**RE: Incorrect Thermal broken Aluminum Joinery: 2 Rapare St. Job No.27363 - JSR Construction.**

Gmail - RE: Incorrect Thermal broken Aluminum Joinery: 2 Rapare St. Job No.27363 - JSR Construction.

**Photo 1:** Path of thermal conduction at the joint of window transom and sliding-door fixed interlocker and the same photo without marking is given side by side for easy reference

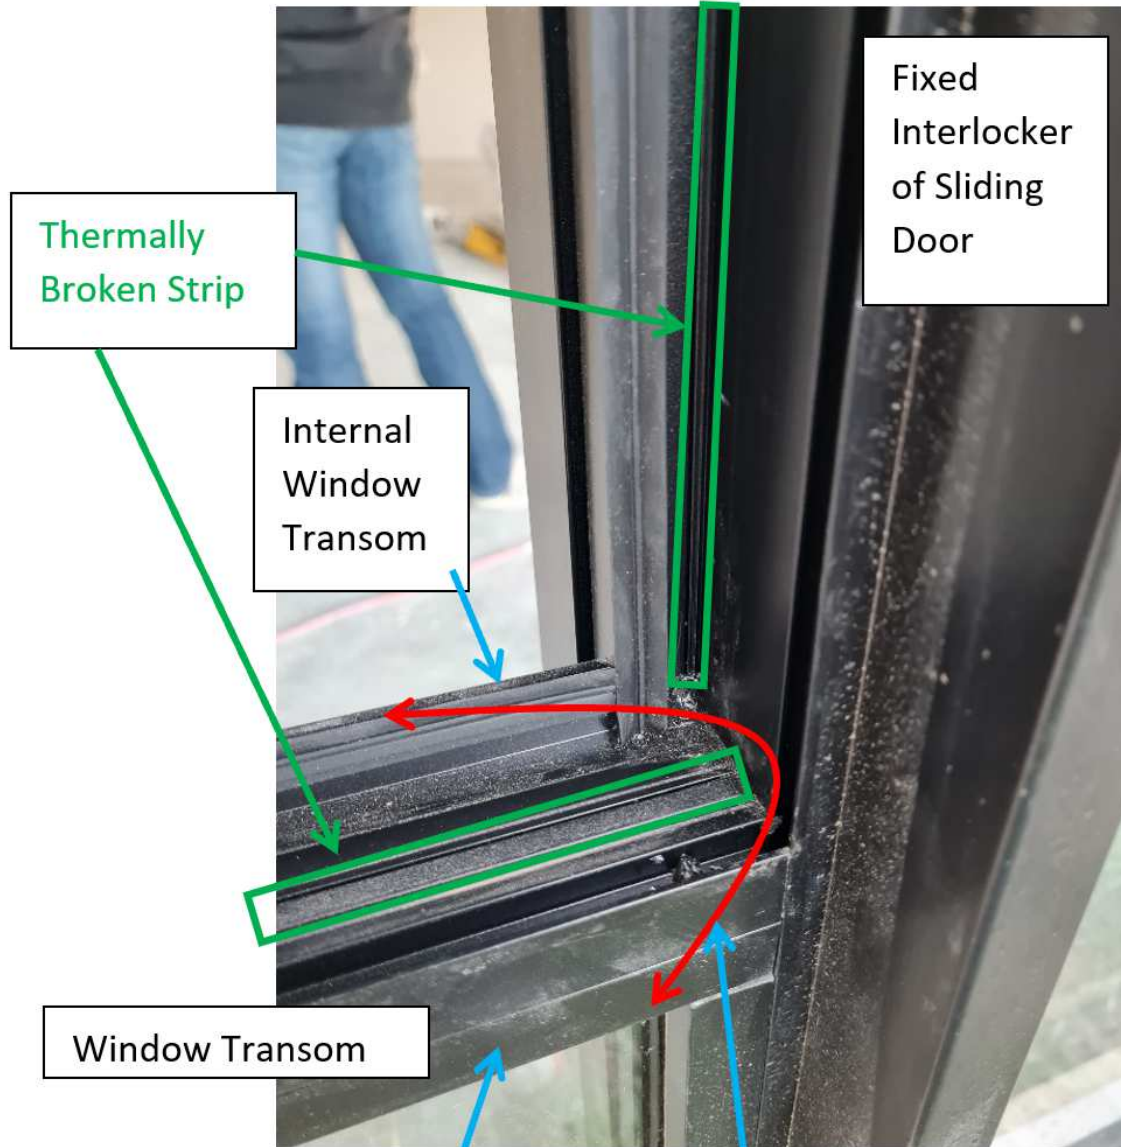
1. You shall replace all non-thermally broken components of the sliding doors and windows which including but not limited to the stiles and fixed interlocker. There is a path of thermal conduction where it is not thermally broken at the joint of the window transom and sliding-door fixed interlocker as indicated by the red line on the marked photo as shown on Photo 1 below. The same photo without marking is given side by side for easy reference. You are required to change the fixed interlocker to have the proper thermally broken strip align with the strip on the window transom. I also took a thermal image (see Photo 2) with the sunshine reaching half the height of the sliding door. It showed that the non-thermally broken components (the joint in between the interlocker and the window transom, and the stiles) creating a thermal conduction between the internal and external parts of the thermally-broken members (e.g. bottom of the sliding door frames and the window transom).

Path of thermal conduction (red line) between internal and external parts of the window

I have mentioned this to Ricky but just wanted to email to confirm that we have agreed to replace the non-thermal extrusions for you.

I can also confirm that the fixed interlocker has already been supplied as a thermally broken extrusion so this will not be changing, there is no other extrusion or alternative here that could be put in its place and APL have only the one thermally broken fixed interlocker which I can confidently say has been installed as you have pointed out in your photo.

Photo 1 – Indicating the non-thermally broken parts of the Sliding Door “Lounge D6” (Door number referred to the attached quote no. 27363) (Trim Size: 2130 x 2700; Area: 5.751 m sq.)

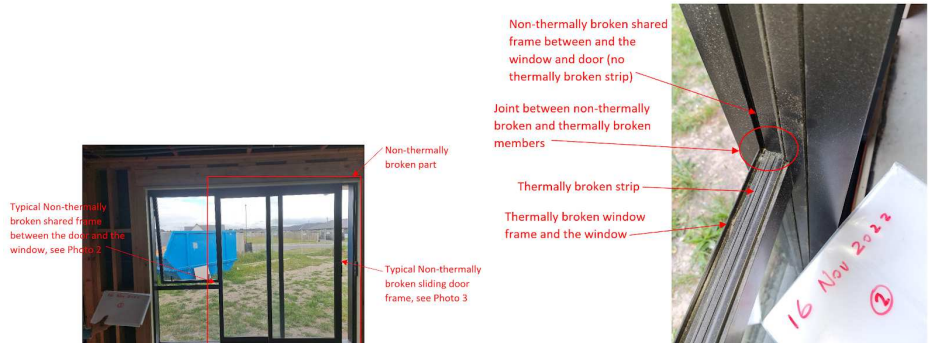
- a) Photo 1 – Indicating the non-thermally broken parts of the Sliding Door “Lounge D6” (Door number referred to the attached quote no. 27363) (Trim Size: 2130 x 2700; Area: 5.751 m sq.)

- c) Photo 3 – Typical slide door frame shows that the slide door does not have thermally broken strip
  - d) Photo 4 – Indicating the non-thermally broken parts of the Sliding Door “Living D6” (Door number referred to the attached quote no. 27363) (Trim Size: 2130 x 2700; Area: 5.751 m sq.)

Figure 1 - Photo location plan

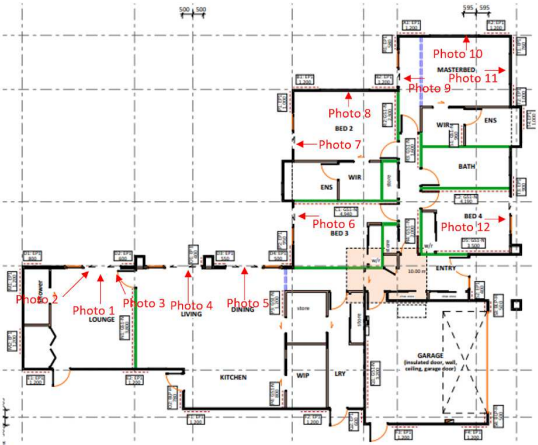
- 1) The parts of the windows and doors frames do not have the thermally broken strip. These windows and doors make up 59% of the area of all the aluminium joinery products. The total area of these problematic aluminium joinery is 28.8 m sq. The total area of all aluminium joinery products is 48.6 m sq. These problematic products are shown in the following photos (note that the photos and the location plan are given at the end of this email):

- 2) The frames of the windows that we are not sure if they are thermally broken or not since the depths of those window frames seems to be smaller than others 32% of the thermally broken joinery by comparing the distances between the frames and the internal and external walls. The total area of these uncertain aluminium joinery is 4.2 m sq. (8.7 % of the total area). These products are shown in the following photos:
